AEI/AEC/B375

Issue 2, 11-Apr-2023
Use until 11-Apr-2025

Changes to Overhead Policy

Clarification of current and addition of new rules

Figure 1: Maximum dimensions for any single CBT, Block Terminal, Box Connection and Coil Bracket system.

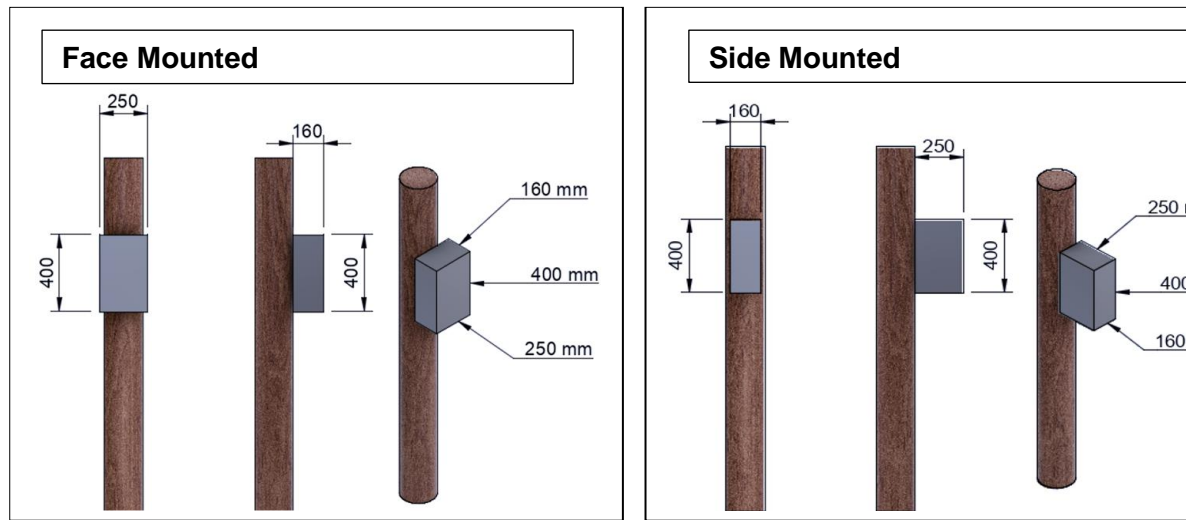
- Any single CBT, Block Terminal or Box Connection must not exceed the maximum dimension requirements shown in Figure 1 below.
- New apparatus must not be placed on a Pole such that it obstructs access to existing equipment
- Where an CBT/Coil Bracket is used, the cable coil must be fully enclosed and not exceed the width profile of the CBT/Coil Bracket. The coil may though extend vertically beyond the CBT, providing that it remains within the upper space envelope (see Figure 2).
- A maximum of 2 x Multiway CBT Brackets can be accommodated on a Pole. These should be mounted on opposing faces.
- Multiway brackets installed by PIA CPs for their exclusive use, may only be deployed where more than 1 CBT is required for the build activity, at that point in time. Multiway Brackets must not be installed with only 1 CBT attached.

Figure 2: Permitted envelopes of space on Poles.

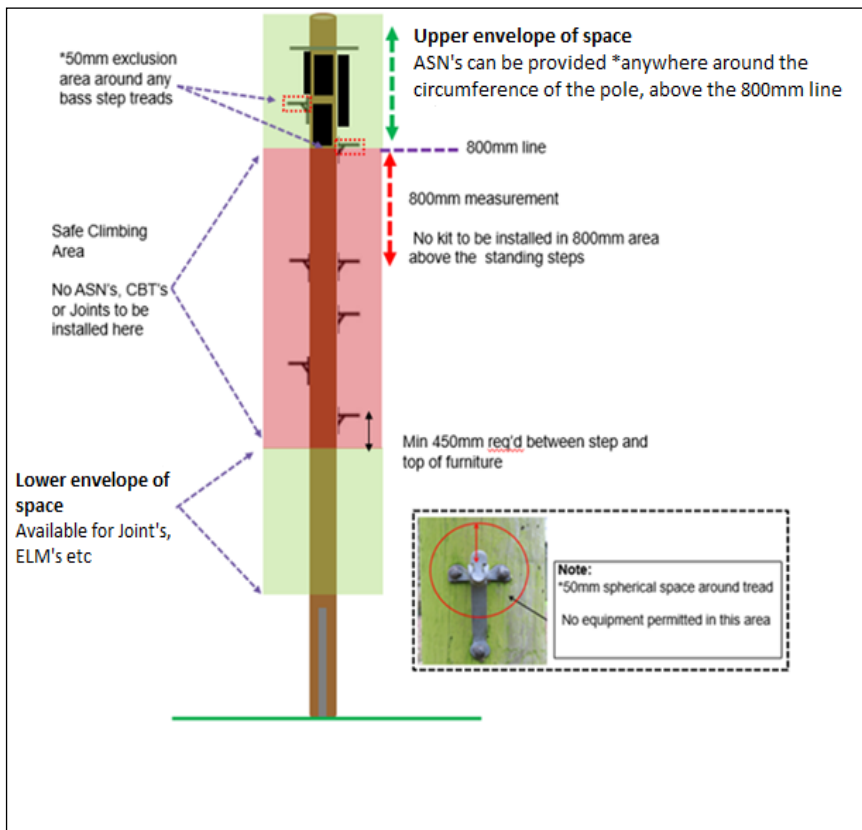
- Items must be securely attached to the pole using appropriate materials
- New apparatus shall only be installed on the pole in the areas shown in Figure 2 below.

Note: Existing equipment installed prior to April 2020, which does not meet the requirements shown in Figure 2, may remain in situ, providing that it does not prevent a handhold of the Bass Steps (see 50mm rule in Figure 2).

- A combined CBT/Coil Bracket system (typically used by PIA CP's) must only be attached onto the side faces of a three-way bracket. The outer face of the bracket must not be used.
- Customer connectivity apparatus e.g. CBTs shall only be provided in the Upper Space Envelope (see Figure 2 below).

- Fibre locking mechanisms (ELM's) shall be located in the lower envelope of space, as shown in Figure 2.
- Where the Lower envelope is being used (for Joints, ELM's etc), a vertical clearance of 450mm must be provided between the Lowermost Climbing Step and the uppermost part of the equipment (Figure 2 refers).
